TRAMMEL CROW
NW RALEIGH COURT
EXCAVATION
EROSION CONTROL PLAN

Request For Information 006

The Vaux
1939 N.W. 24th Avenue, Portland, OR 97210
Project # 062608
Tel: 503.243.4004 Fax: 503.243.6116
TCR Construction

TRAMMEL CROW
NW RALEIGH COURT
SITE
UTILITY PLAN

SHEET
UP-1

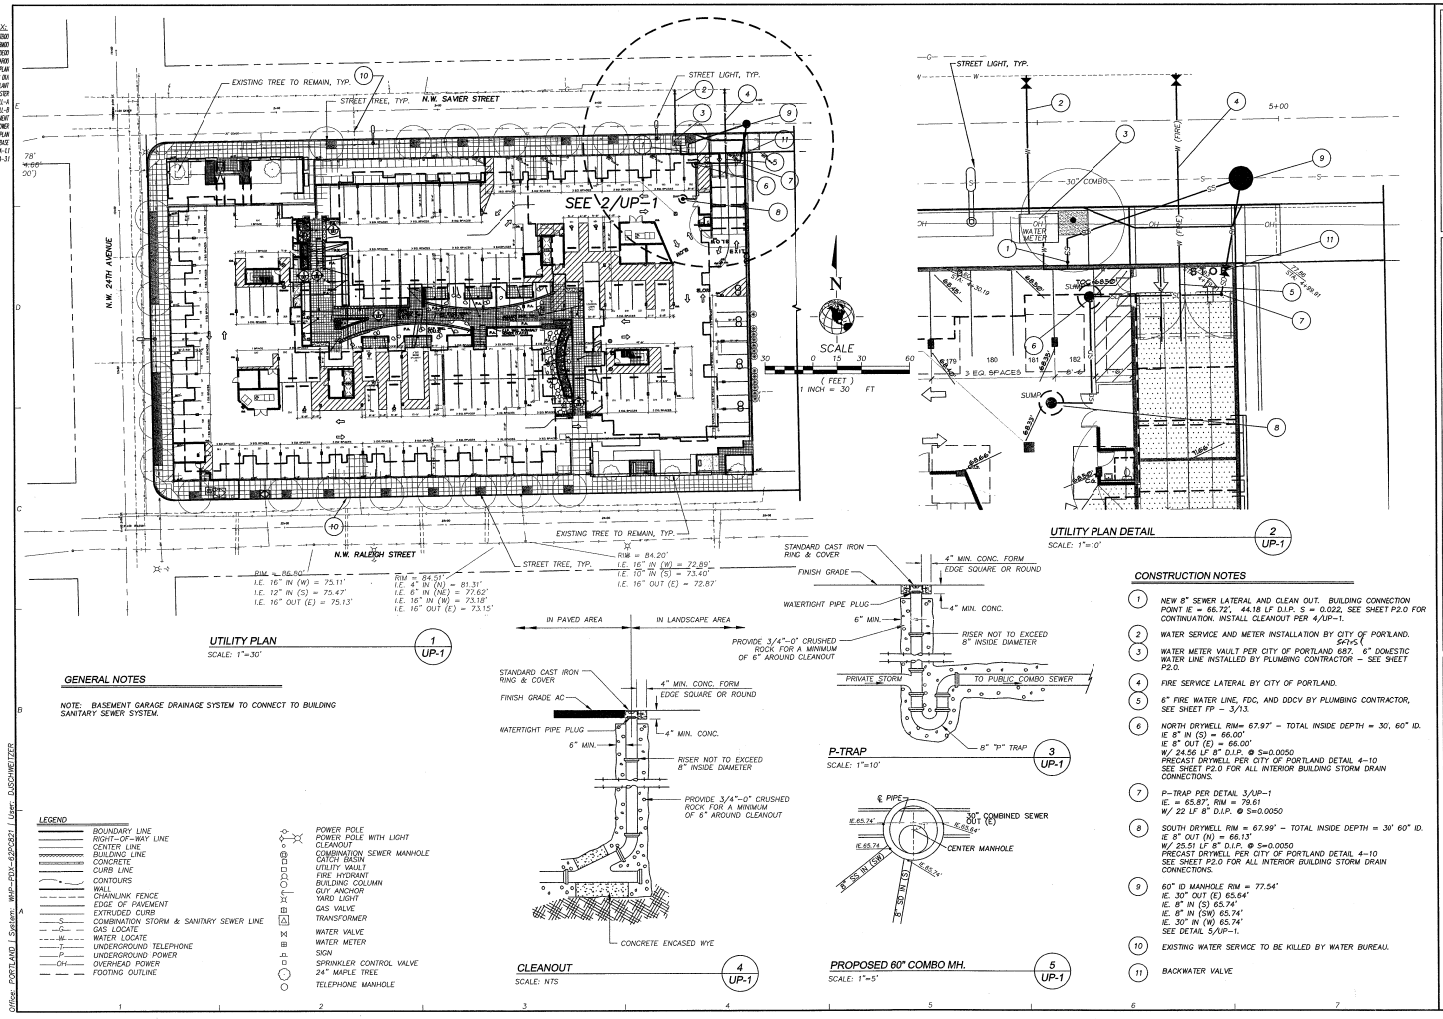
Question: Date Required: 2/7/2005
It has become apparent that our excavation is not able to locate a 60" drywell locally. Please confirm whether it would be acceptable to use a 48" drywell in lieu of the 60" shown. Per the conversation earlier with Steve Jones and Dave Poulsen, please confirm the performance spec that the drywells must perform with.

Answer: Date Answered:
Based on cut submitted to the city of Portland we established an infiltration rate of 135 gallons per well. Based on the infiltration tests provided by GRI, a 125 gallon rate is likely achievable using a 30 foot deep 48" drywell as opposed to a 20 foot deep 60" drywell.

a few caveats:

1) The infiltration tests show a substantial infiltrative zone increase at depths exceeding 25 feet. This corresponds to the loose gravel soil conditions found at that approximate depth - an attempt to fully penetrate the loose gravel (2 feet deep) is highly recommended to achieve the desired infiltration rates provided above.

2) A geotechnical engineer should monitor the installation and control infiltration tests methods and their implementation - contact Mike Rosso at GRI to coordinate his schedule and his prior notice requirements.

3) IMPORTANT - Under no circumstances will any water be allowed in the new drywells until all construction is complete. The only water that should enter the drywells will be from stormed roof or paved surfaces. One of the main causes of drywell failure is from silt laden - construction site stormwater runoff. Even construction site stormwater that is treated with silt fences/sedimentation ponds can not be discharged into a drywell installed in this plan sets. If pumping water in the basement/ excavation needs to be disposed - either provide a temporary sediment sump or use dewatering pumps.
